## Cycle Superhighway Number 3 (East West Cycle Superhighway): Comments on revised proposals supplied by Transport for London

This document sets out further comments and concerns, which need to be addressed following an evaluation of the proposals as summarised in this document.

- 1.1 The purpose of this technical note is to provide a briefing on the revised TfL scheme design and modelling for the East West Cycle Superhighway (EWCS) to be known as Cycle Superhighway Number 3.

**East-West Cycle Superhighway**  
**Technical Note TN03 May 2015**  
**Review of revised EWCS scheme on behalf of Westminster City Council**  
**LANCASTER GATE**

Figure 1: ONE Model revised scheme traffic forecast versus the base traffic scenario – AM Peak

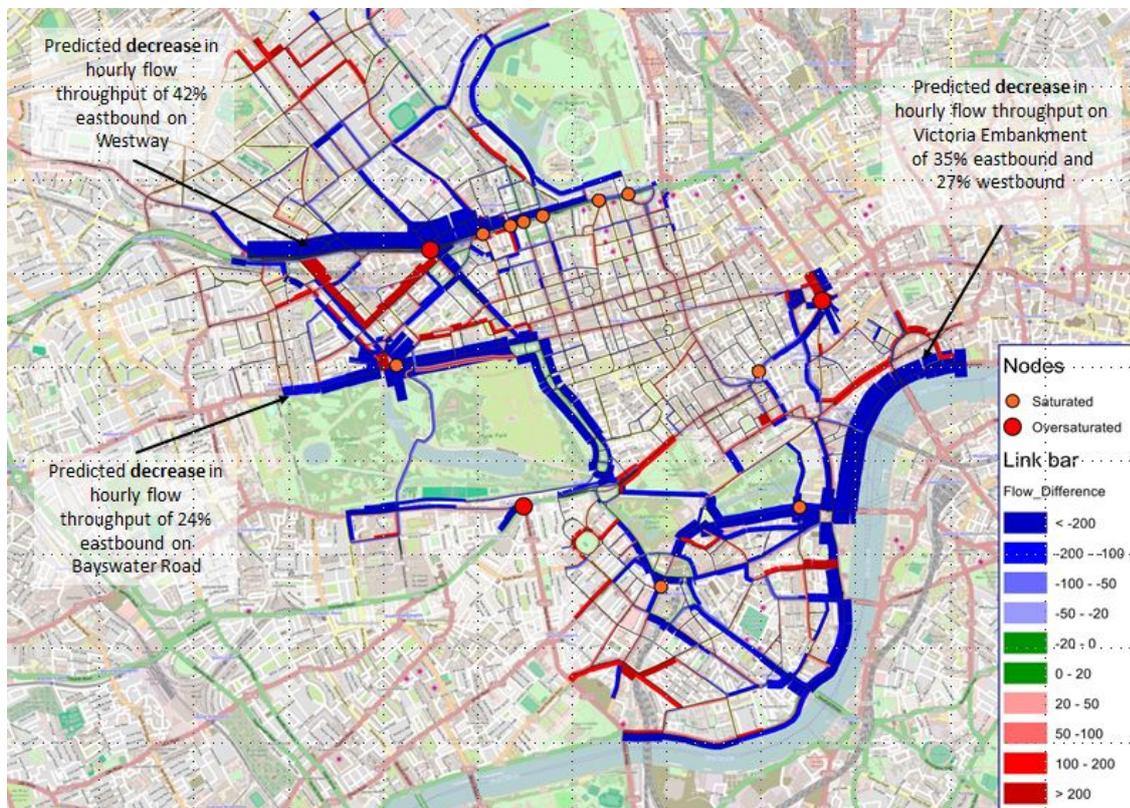
4.2 TfL forecasts that the revised scheme traffic impact will be significant (flow increases between 100-200 vehicles per hour, or traffic flow increases >200 vehicles per hour to an unspecified degree) on a number of Westminster streets. Key routes that are likely to experience significant increases in traffic demand include:

- 4.5 In relation to the current consultation, local stakeholders Paddington Residents Active Concern on Transport (PRACT) has concerns that the forecasts for the Lancaster Gate area are not realistic. It seems unlikely that Westbourne Terrace and Praed Street are suitable routes to accommodate any significant increase in general traffic as a diversion to A40 Westway, given the current degree of 'friction' with buses and taxis on this route.

- 4.6 Strand is also unlikely to be able to accommodate the increases in traffic demand predicted, and this is likely to cause significant congestion and delay, unless further mitigation is applied.

Figure 3: ONE Model revised scheme traffic forecast versus previous scheme – AM Peak

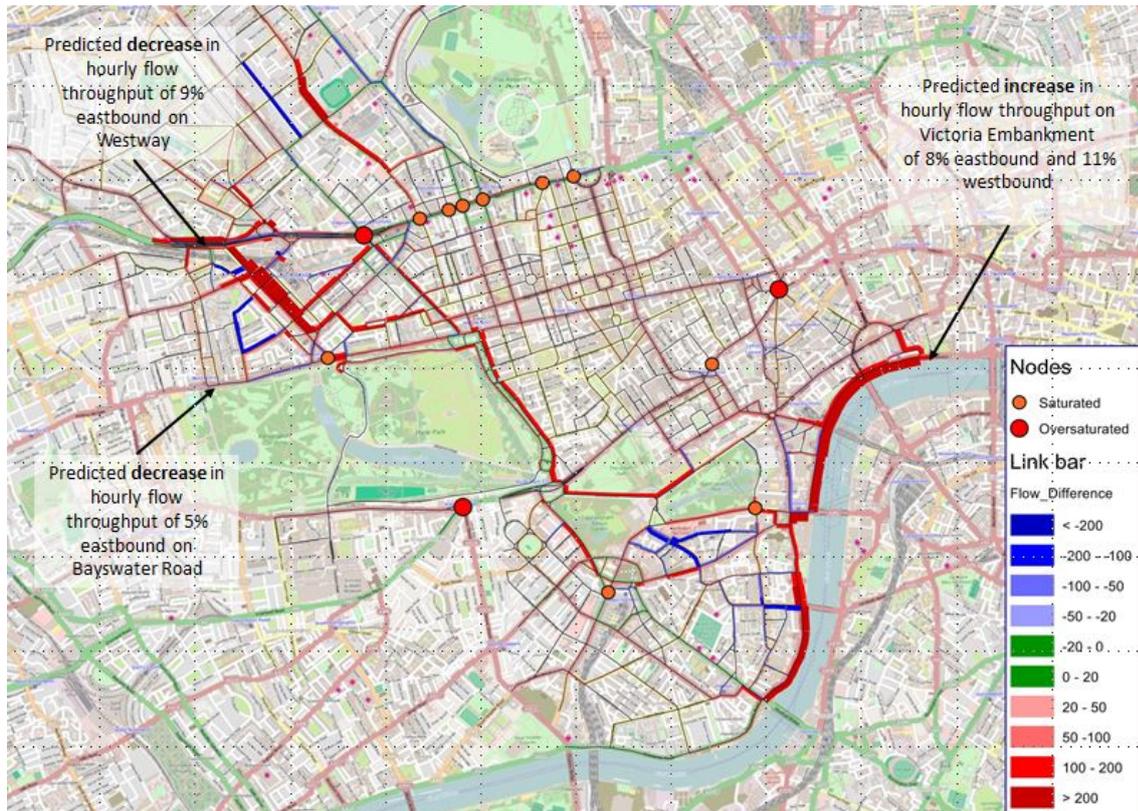
- 4.7 TfL forecasts that the revised scheme can allow significantly more traffic into the area on Victoria Embankment than the previous scheme, which means that more traffic will remain on routes such as Edgware Road, Park Lane, Millbank and through Victoria. However, the higher volumes may mean that there is likely to be a greater degree of rat-running on local roads as a consequence of the capacity restraints on the network.

**Figure 5: Lancaster Gate design comments**

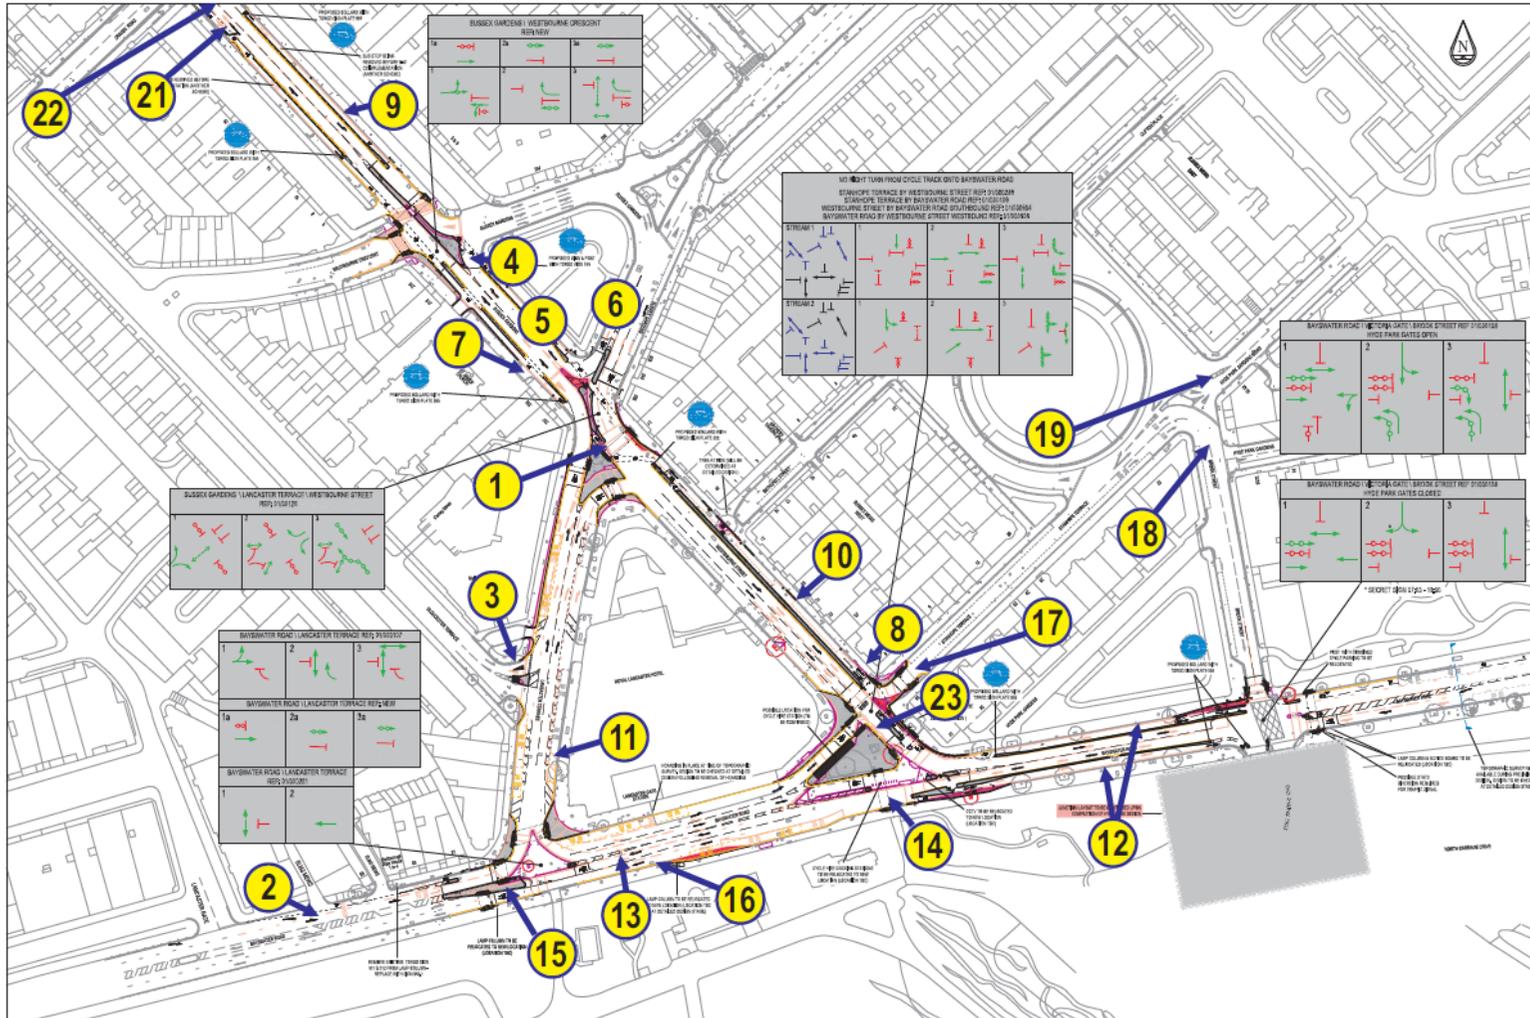
9.1 The review of the revised scheme design at Lancaster Gate has identified a number of concerns (see Table 5). Reference is made to locations shown on Figure 5.

Ref	Comment
General item A	The revised scheme retains a proliferation of separate traffic signal controlled phases for traffic movements, cycle tracks, contra-flow cycling and pedestrians with multiple stop lines for some movements. Sections of this arrangement will be challenging for users to understand, and could result in a high risk of non-compliance by cyclists at traffic signals, with potential risk of collisions.
B	The complexity of the control arrangement for cyclists is likely to result in excessive delay for cyclists, meaning that quieter, parallel routes that link either into or east of Hyde Park (e.g. Albion Street) are likely to be far more attractive routes to many cyclists. An excessive number of stop lines are crossed by each cyclist using the East-West Cycle Superhighway within the Lancaster Gate area.
C	The revised scheme introduces an east-west 'tube' for cyclists yet there are locations where entry/ exit of this new facility by cyclists to/from City of Westminster roads is not entirely catered for in a desirable manner (e.g. Bayswater Road, Westbourne Crescent, Sussex Gardens, Gloucester Terrace, Sussex Square).

<p>movement from Westbourne Terrace to Lancaster Gate is re-routed to Gloucester Terrace within the VISSIM traffic model, and affects traffic demand on this approach. This also means that a traffic management strategy is required at the Craven Road/ Gloucester Terrace junction, which is not reported in any detail. The scheme design does not propose a formal diversion of traffic (which could only be in the form of signing), and so there are not any measures that would prevent/ deter traffic from travelling from Westbourne Terrace to Westbourne Street via the Sussex Gardens Gyratory. This could result in greater traffic impact on Westbourne Terrace than is reported in VISSIM modelling.</p>
4	<p>Paddington Residents Active Concern on Transport (PRACT) has requested, with the support of the City Council, that TfL consider options for introducing a pedestrian crossing to the centre of Sussex Gardens. TfL has yet to demonstrate how this can be achieved. It is felt that the significant traffic flow reductions would provide opportunity for a facility to be provided.</p>

Craven Road at this time due to the continued traffic diversions associated with Crossrail.
10	The revised scheme results in the loss of all resident permit holder parking spaces on Westbourne Street. There is reasonable alternative provision in Sussex Square and Stanhope Terrace.
11	The revised scheme includes additional bus stand kerbside space replacing a section of existing timed on-street loading in Lancaster Terrace, thus reducing capacity. The operation of the stand may be affected by the presence of an existing tree, and this should be reviewed.
12	The revised scheme results in a loss of timed on-street loading and parking capacity along both sides of Bayswater Road to accommodate cycle track infrastructure. This could create a displaced parking issue for overnight and Sunday parking and will need to be reviewed.
13	The westbound right turn from Bayswater Road to Lancaster Terrace is controlled separately from the westbound ahead traffic, yet there is no separating island between the lanes. It is understood that TfL is reviewing this arrangement.

22	EWCS infrastructure not to extend north of Craven Road at this time (see point 9).
23	Stakeholders (SEBRA, PRACT and residents of Stanhope Terrace) with the support of the City Council request two southbound lanes are provided at the junction on Westbourne Street from Stanhope Terrace to Bayswater Road. This is intended to provide junction capacity and vehicle queue resilience. The loading bay outside the hotel would require restrictions to enable the flared approach to provide additional capacity and it is suggested that the loading bay operates at all times except between 8am and 10 am and 4pm to 7pm, Monday to Sunday. This is illustrated on the sketch layout shown on Figure 6.
